UNITED STATES PATENT AND TRADEMARK OFFICE

APPLICATION NO.	FILING DATE	FIRST NAMED INVENTOR	ATTORNEY DOCKET NO.	CONFIRMATION NO.
09/614,155	07/11/2000	Dan A. Steinberg	ACT-121	1603

Office Action Summary	Application No. 09/614,155	Applicant(s) STEINBERG ET AL.	
	Examiner Hae Moon Hyeon	Art Unit 2839

DETAILED ACTION

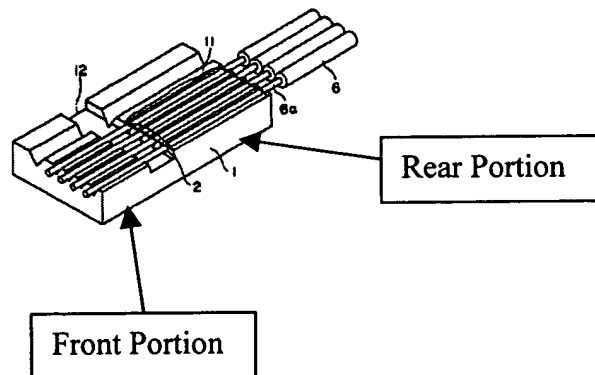
13. Claims 1, 3, 23, and 24 are rejected under 35 U.S.C. 102(b) as being anticipated by Yamashita et al (JP410227948A).

Yamashita discloses an optical fiber array apparatus comprising a V-groove chip 1 and an optical fiber 6. The V-groove chip 1 has a V-groove 2, a rear portion, a front portion, a front face and a wick stop trench 12. The optical fiber 6 is disposed in the V-groove 2. The optical fiber 6 is not bonded to the front portion of the chip 1, but the optical fiber 6 is bonded (at point B) to the rear portion of the chip 1. The optical fiber is extending from the rear portion. The wick stop trench 12 is in between the rear portion and the front portion.

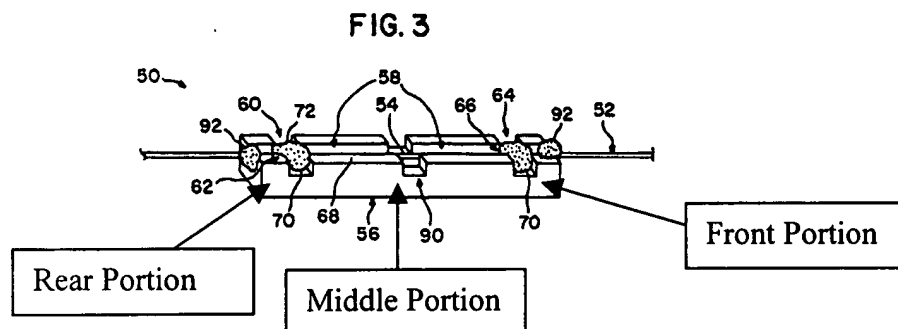
16. Claim 12 is rejected under 35 U.S.C. 103(a) as being unpatentable over Yamashita et al in view of Yamane et al (5,557,95) or Murphy (4,639,074).

Claim 12 recites that the V-groove in the front portion has a flat bottom surface, but Yamashita does not disclose a flat bottom surface for the V-groove in the front portion.

Yamane discloses an optical fiber apparatus having V-groove 24, 26 or V-groove with a flat bottom surface 14, 16. Murphy also discloses an optical fiber apparatus having V-groove with a flat bottom surface (see Figs. 2-5).

It would have been obvious at the time the invention was made to a person having ordinary skill in the art to provide a V-groove with a flat bottom surface because this would provide a stronger substrate compared to a substrate with a V-groove.
